SANITARY SEWER PLAN & PROFILE

C.401

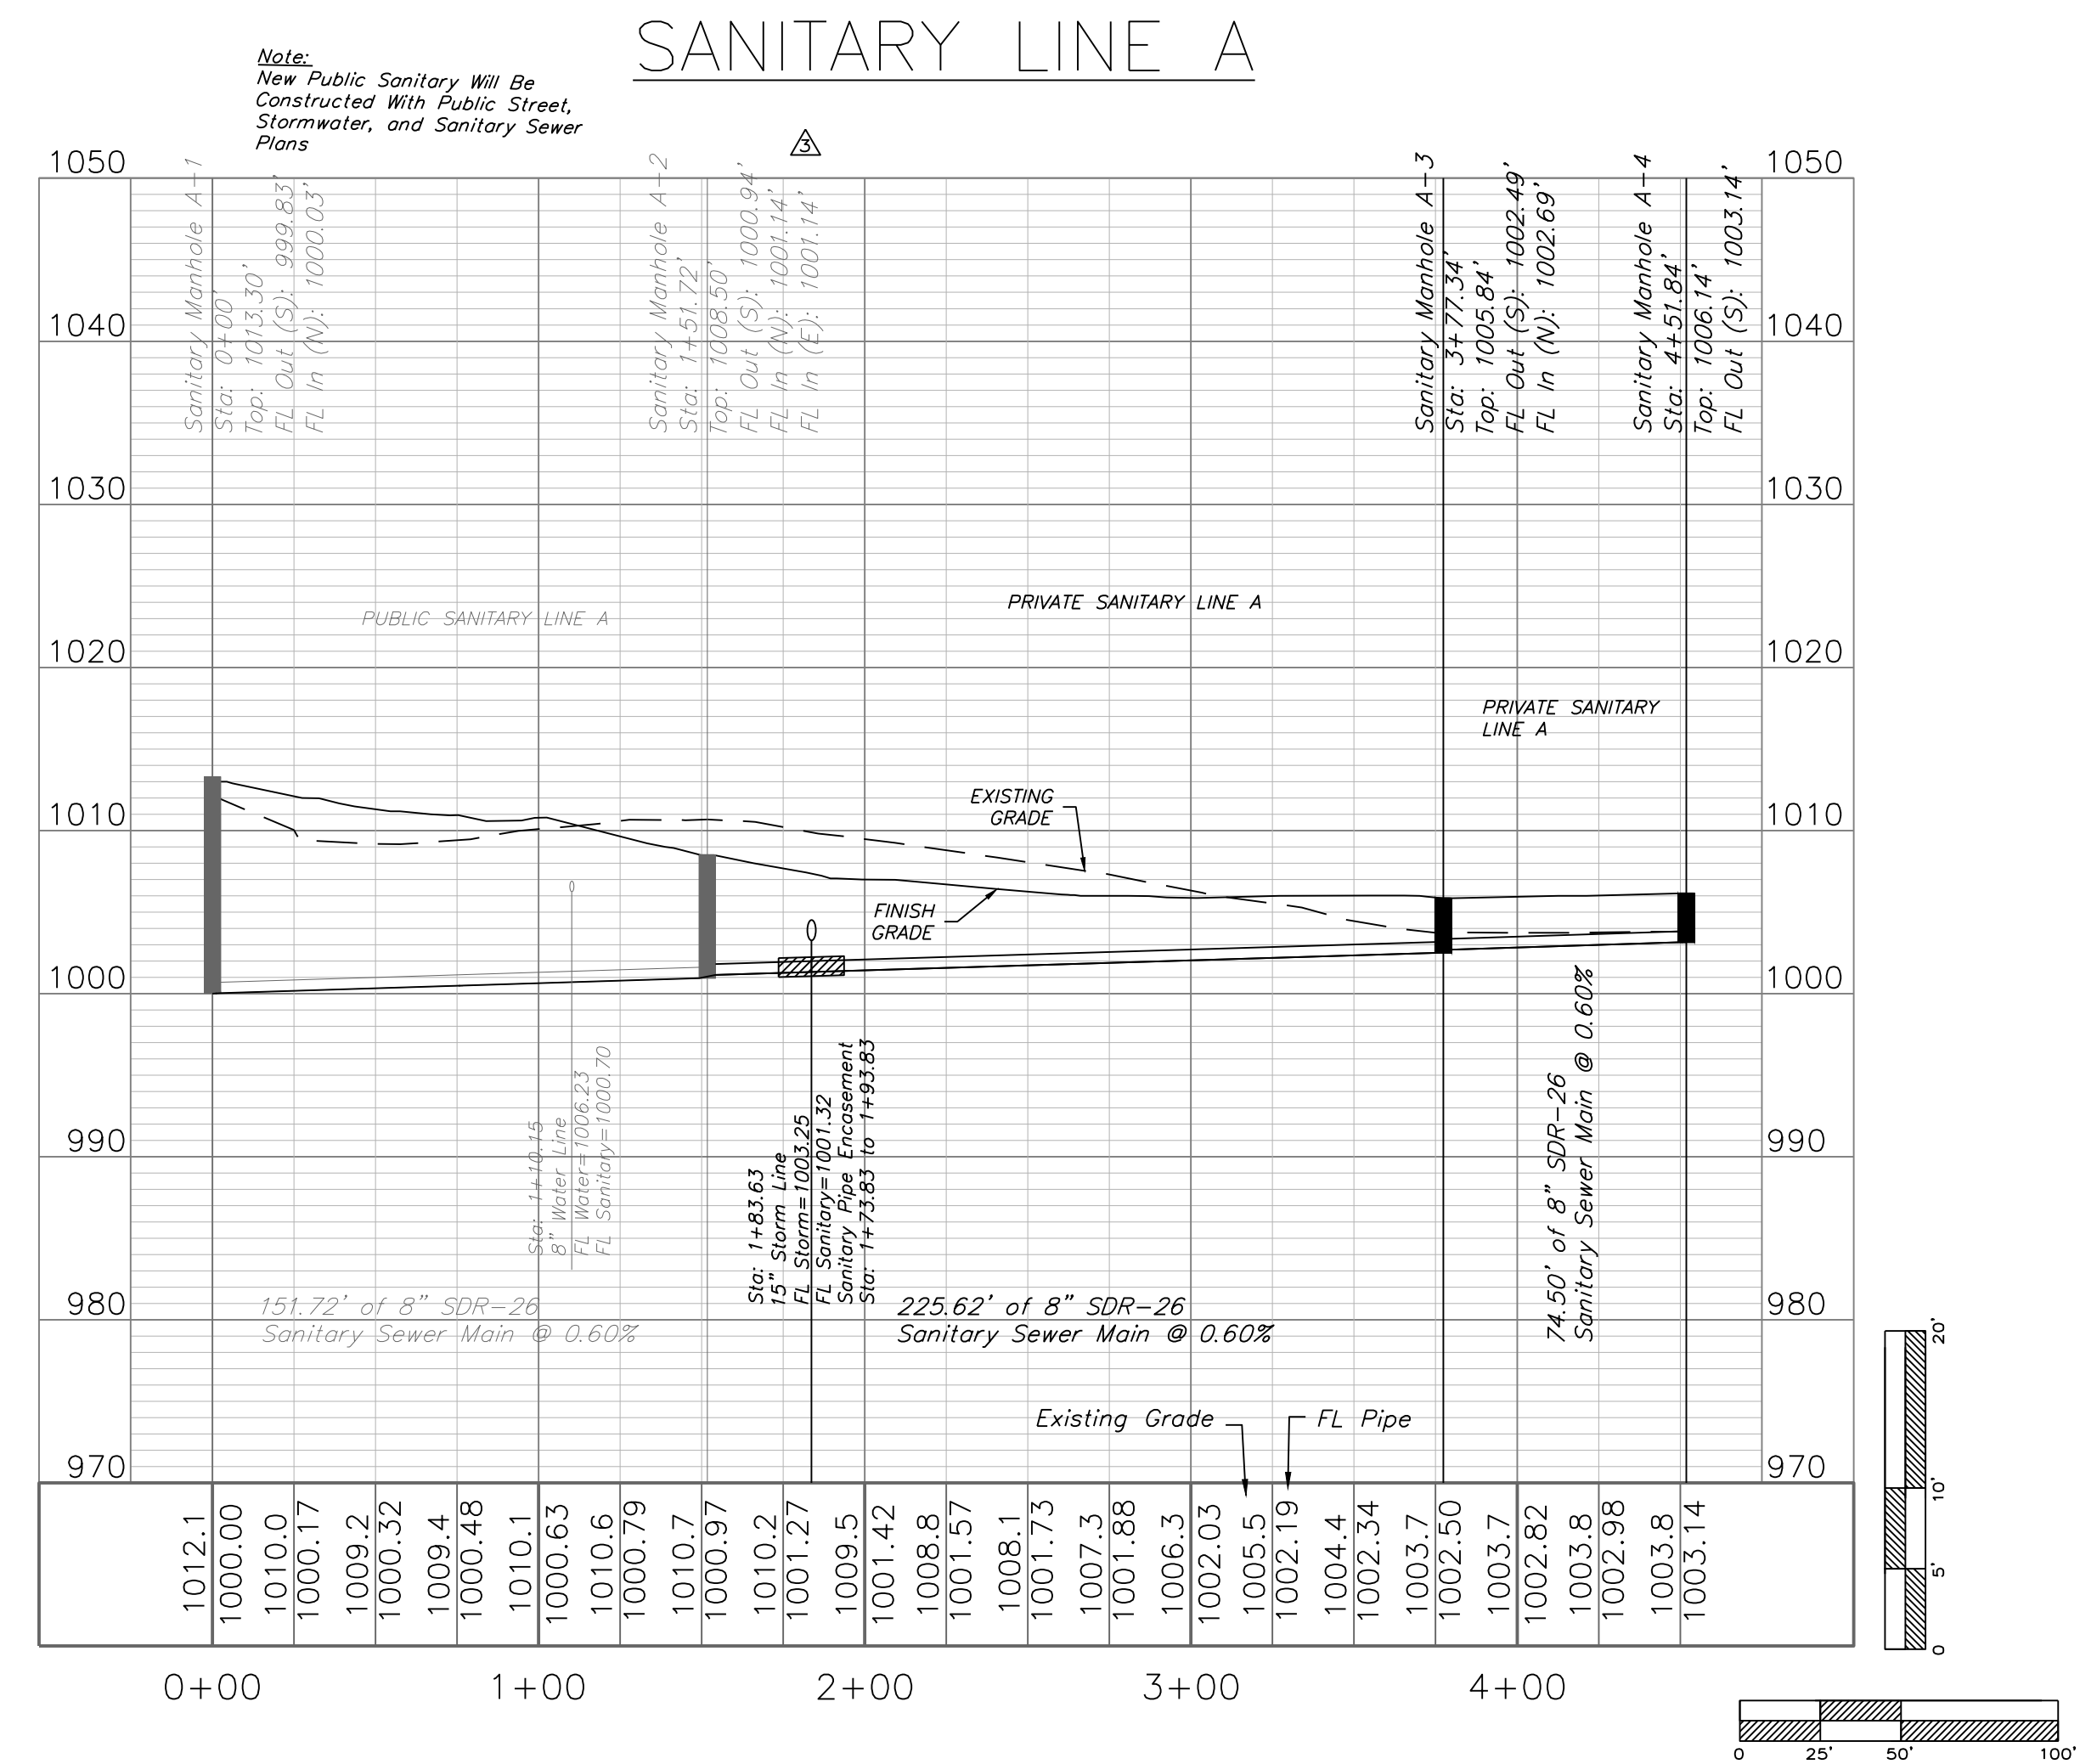
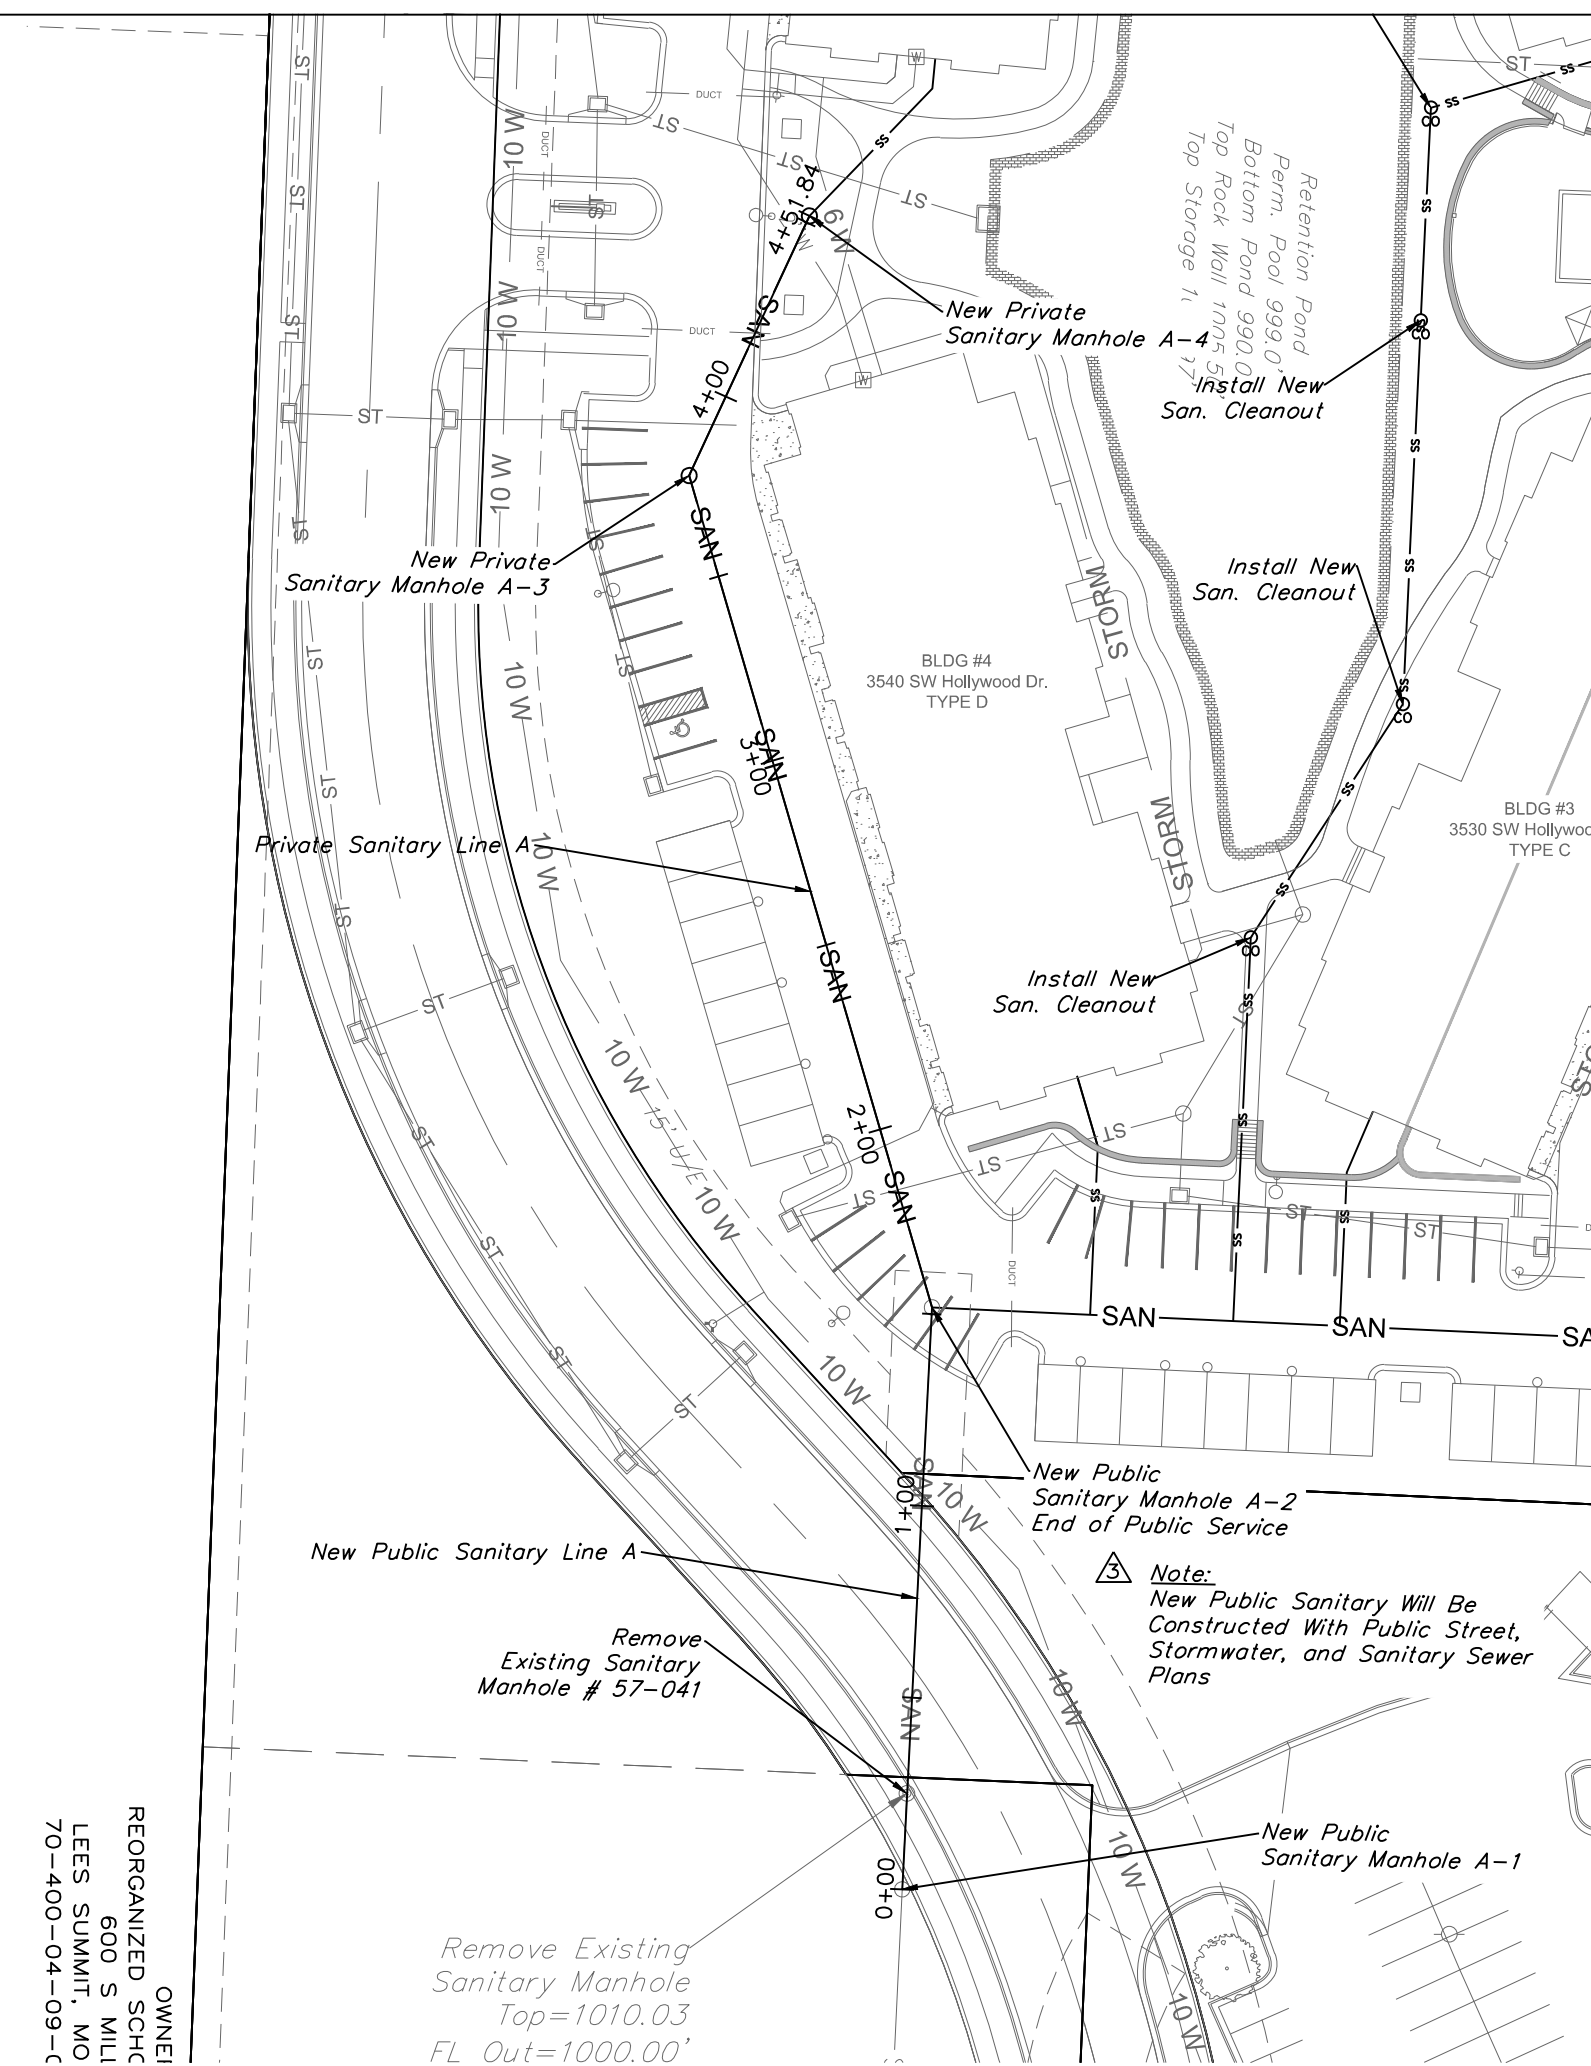
-  **REV 3-21-17**
- Planning Review
1. Relocated the monument signs to be outside the easements.
 8. Updated the building addresses as requested.
- Engineering Review
2. Labeled the sanitary and water lines as private as requested.
 14. Removed the cover sheets for the private water and sanitary.
 16. Reconciled the manholes to the correct heights.
 19. Provided the requested cleanouts for the sanitary stubs.

-  **REV. 5-3-17**
- Engineering Review
23. Provided the Off-Site Sanitary Extension with this submittal.
24. Provided a separate Plan and Profile for the Existing Sanitary Sewer.
25. Reconciled the labels for the Public and Private Sanitary Lines.
26. Added the Missing Flowline In.
30. Enlarged text size and provided legend.
